UNITED STATES PATENT AND TRADEMARK OFFICE

APPLICATION NO.	FILING DATE	FIRST NAMED INVENTOR	ATTORNEY DOCKET NO.	CONFIRMATION NO.
10/542,041	02/28/2006	Jean-Pierre Schoellkopf	S1022.81095US00	8689
46329	7590	11/17/2008	EXAMINER	
STMicroelectronics Inc. c/o WOLF, GREENFIELD & SACKS, P.C. 600 Atlantic Avenue BOSTON, MA 02210-2206			CLARK, JASMINE JHIHAN B	
			ART UNIT	PAPER NUMBER
			2815	
			MAIL DATE	DELIVERY MODE
			11/17/2008	PAPER

DETAILED ACTION

FIG. 11

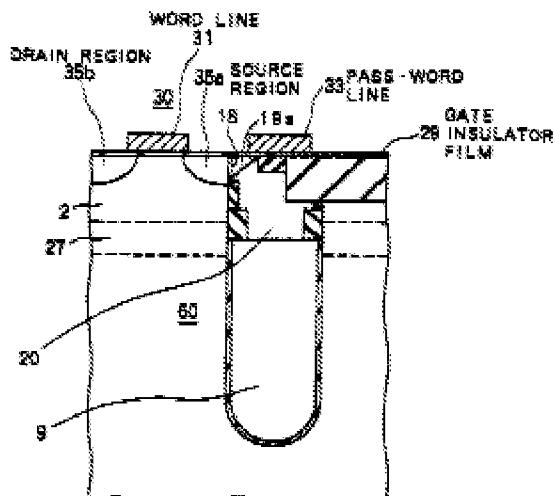
Claims 11 and 12 are rejected under 35 U.S.C. 102(b) as being anticipated by Sudo et al. (US 6,204,527).

Sudo '527 discloses at least one capacitor formed on an IC substrate, the at least one capacitor comprising: a first electrode 35a, for example of MOS transistor, a first capacitor dielectric region 60 having at least a portion that contacts the first electrode 35a and is buried beneath the first electrode; and a second electrode 20 buried beneath the first electrode, the second electrode being insulated from the first electrode, wherein the second electrode is electrically connected to a gate 31 of the MOS transistor.
